THE SERVICED GRID CODE – ISSUE 4 REVISION 1

THE GRID CODE – ISSUE 4 REVISION 2

THE GRID CODE – ISSUE 4 REVISION 2

SUMMARY OF CHANGES

**POWER PARK MODULE PERFORMANCE CHART
AT THE CONNECTION POINT OR USER'S SYSTEM ENTRY POINT**

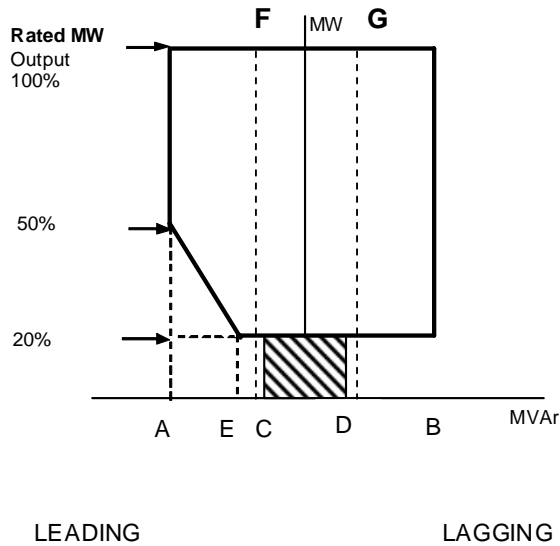
Where a **Reactive Despatch Network Restriction** is in place which requires following of local voltage conditions, alternatively to (E), please check this box.

- Point A is equivalent (in MVAR) to: 0.95 leading **Power Factor** at **Rated MW** output
- Point B is equivalent (in MVAR) to: 0.95 lagging **Power Factor** at **Rated MW** output
- Point C is equivalent (in MVAR) to: -5% of **Rated MW** output
- Point D is equivalent (in MVAR) to: +5% of **Rated MW** output
- Point E is equivalent (in MVAR) to: -12% of **Rated MW** output
- Line F is equivalent (in MVAR) to: Leading **Power Factor Reactive Dispatch Network Restriction**
- Line G is equivalent (in MVAR) to: Lagging **Power Factor Reactive Dispatch Network Restriction**
